SHD0019/22 North West Corner of Omni Park Shopping Centre, Santry Hall Industrial Estate, Swords Road, Santry, Dublin 9.

Comments by DCC Parks, Biodiversity & Landscape Services

October 14th 2022

Proposed Master Landscape Plan

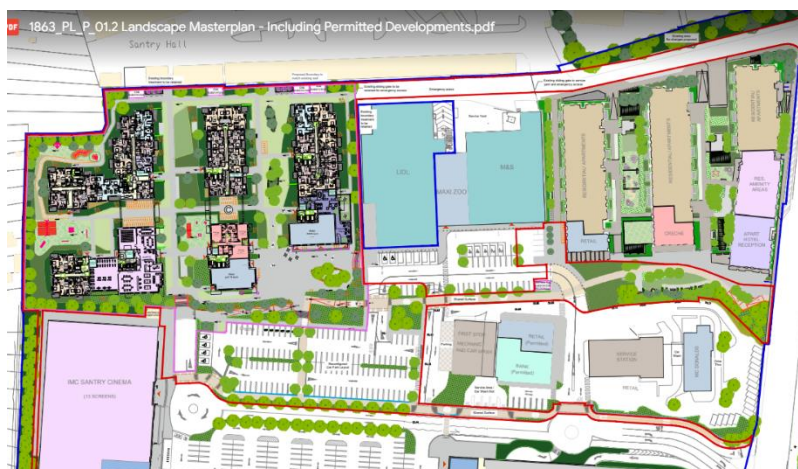
The public open space provision includes a plaza space fronting the development. The total provision is stated at 2039m², which meets the 10% site POS requirement of 1549m².

The quality of the materials used within the plaza should be improved with the full use of natural stone surfacing. In addition, the use of large-canopy tree species and public art shall help to improve greening and sense of identity to the development.

The application indicates a provision of 3552m² which meets the required 2802m². COS should be distinct from public areas by use of boundaries so that privacy and security is maintained for future residents. Additional active recreational elements, such as basketball half court, external gym units should be included. Play space generally meets guideline requirements.

- a. The public open space with all paved areas constructed in natural stone.
- b. The enclosure of communal open space areas.
- c. The inclusion of active recreational elements (basketball & external gym units) within the communal open space.
- d. The enclosure of the crèche play-space.
- e. A high quality public artwork in the public open space plaza.
- f. The expansion of green roofs coverage on all flat and gently sloped roofs.

3.4 Crèche

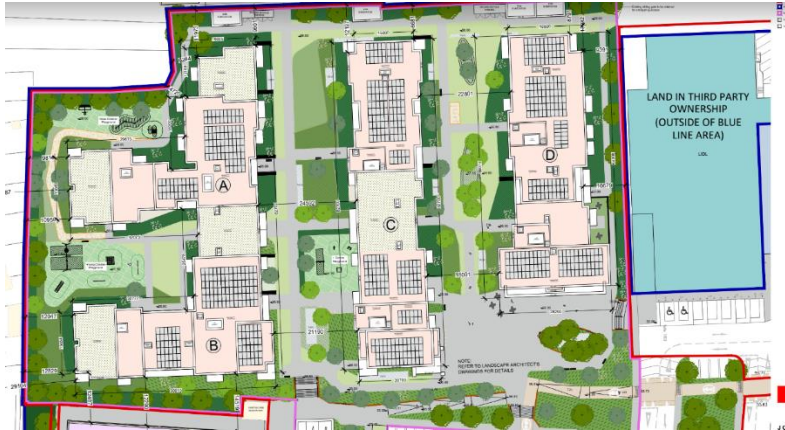
The crèche external play space shall be fully enclosed.
